Staff Report Z-16-18-5 May 1, 2018

Proposed Use: Single-Family Residential

Location: Northeast corner of Loop 101/Agua Fria

ADDENDUM A Staff Report: Z-16-18-5

Zoning sketch
Aerial
Conceptual Site Plan date stamped March 08, 2018
Renderings and Floor Plans date stamped March 13, 2018 (28 pages)
Circulation Plan date stamped April 19, 2018

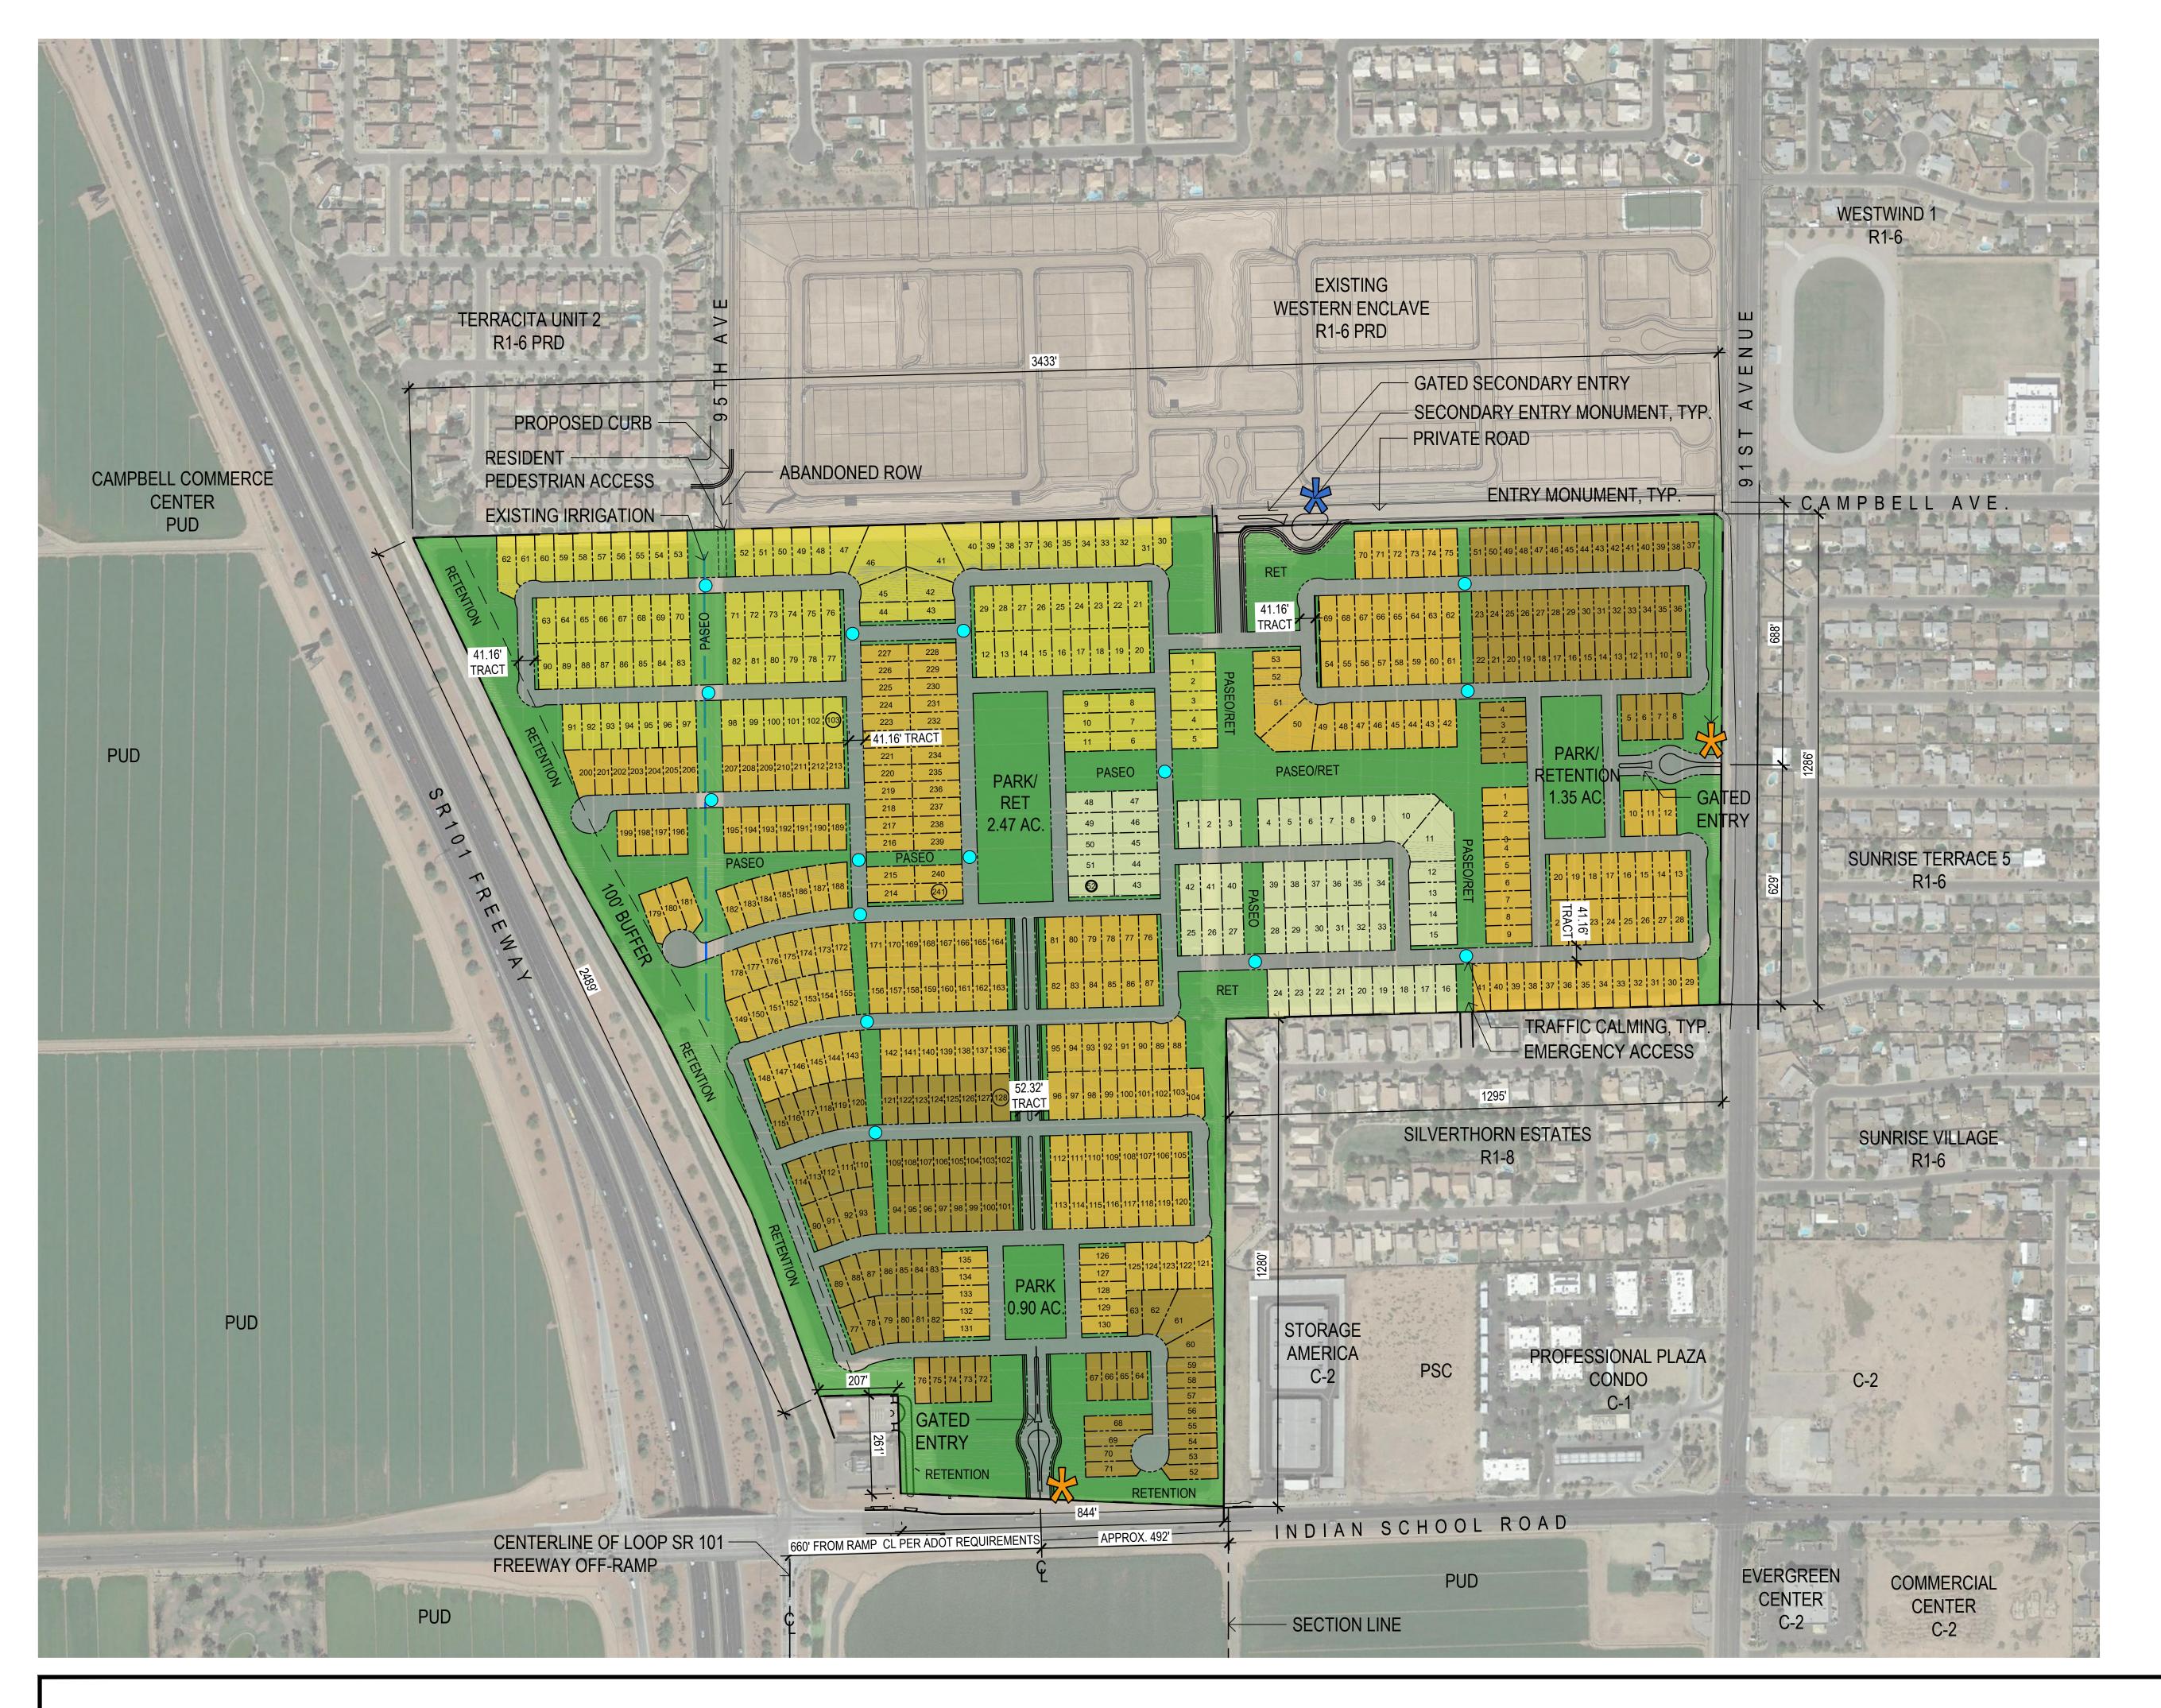
4. The proposed site plan shows a 524-lot single-family subdivision with gated vehicular access and entry monuments identified at Campbell Avenue, 91st Avenue, and Indian School Road. Staff is recommending a stipulation that the project shall not exceed 524 lots. This is addressed in Stipulation 1.

- 5. A private internal street network is depicted throughout the subdivision with one resident access gate located to the north, in alignment with the existing 95th Avenue "stub" street that was constructed as part of the subdivision to the north. The proposed site plan depicts an emergency access only to the southeast in alignment with the existing 92nd Avenue "stub" street that was constructed as part of the subdivision to the southeast. The proposal does not depict any publicly accessible vehicular, pedestrian, or bicycle connections to either existing "stub" streets constructed by the subdivisions to the north (95th Avenue) or the southeast (92nd Avenue). Multimodal (vehicular, pedestrian, and bicycle) connections to the existing single-family residential subdivisions to the north and southeast will create a larger integrated neighborhood and serve to create connectivity to allow alternative modes of access and interaction between residents. Staff highly recommends the subdivision layout be reconfigured to better integrate with the existing surrounding neighborhoods and communities.

- 7. Approximately 26 percent open space is depicted on the site plan in the form of park/retention, paseo/retention and buffer/retention areas. Staff is recommending a stipulation that a minimum of 15 percent open space be provided to ensure compatibility with the scale and character of existing neighborhoods. This is addressed in Stipulation 2.

- 8. The conceptual site plan depicts an average 100-foot-wide buffer/retention area along the west boundary adjacent to the Loop 101/Agua Fria Freeway. Given the size of the landscape setback staff is recommending additional trees be planted to ensure that the area has adequate shade and screening. The circulation plan depicts a private pedestrian pathway for a short distance along the eastern edge of this 100-foot buffer/retention area. Staff is also recommending a stipulation that this 100-foot-wide setback include a pedestrian pathway for the full length of the western boundary. These provisions are addressed in Stipulation 3 and 4.

- 9. The proposed site plan shows gated vehicular access and entry monuments identified at Campbell Avenue, 91st Avenue, and Indian School Road. Staff is recommending a stipulation that a landscaped entry and monument sign(s) be provided at each entryway into the development. This is addressed in Stipulation 5.

- 10. The proposed Circulation Plan shows detached sidewalks at entryways and where adjacent to perimeter public streets, however, detached sidewalks are not shown for the remainder of the developments internal street network. To ensure that the proposed development contributes to the larger neighborhood's connectivity is an important part of its contribution to the area's livability. The creation of a shaded internal pedestrian network connecting all the development's residences with each of the designated open space areas and adjacent amenities (existing and planned), coupled with detached sidewalks and street trees, will further establish the development as a safe, shaded, healthy, and "walkable" community. Creating connected healthy communities is called for in the General Plan. It is recommended that all sidewalks be detached from the curb and a landscape strip be planted with trees between the curb and the sidewalk. The combined landscaping with trees, detached sidewalks and landscape strip, are consistent with the guiding policies and principles in the General Plan and encourage a safe and walkable neighborhood environment. This is addressed in Stipulation 6.

- 1. The project shall not exceed 524 lots.
- 2. A minimum of 15 percent of the gross site area shall be retained as open space, as approved by the Planning and Development Department.

- 3. An average 100-foot-wide landscape setback shall be provided and maintained along the west boundary of the development as approved by the Planning and Development Department. Landscaping within the setback shall include a double row of trees with a minimum mixture of 1-½ inch (50%) and 1-inch (50%) caliper trees planted at a minimum of 20 feet on center or in equivalent groupings, as approved by the Planning and Development Department.

- 4. A pedestrian pathway shall be provided along the full length of the western boundary, within the 100-foot-wide landscape setback in accordance with the City of Phoenix standard trail detail, as approved by the Planning and Development Department.

- 5. A landscaped entry and monument sign(s) shall be provided at each entryway into the development from 91st Avenue and Indian School Road. The landscaped entries shall be a minimum of 250 square feet and be planted and maintained with a variety of at least three different plant materials, as approved by the Planning and Development Department.

6. All sidewalks shall be detached with a minimum five-foot-wide landscaped strip located between the sidewalk and back of curb and shall include minimum 2-inch caliper shade trees planted a minimum of 20 feet on center or in equivalent groupings along both sides of the sidewalk, as approved by the Planning and Development Department. The landscape strip shall be installed by the developer and maintained by the property owner.
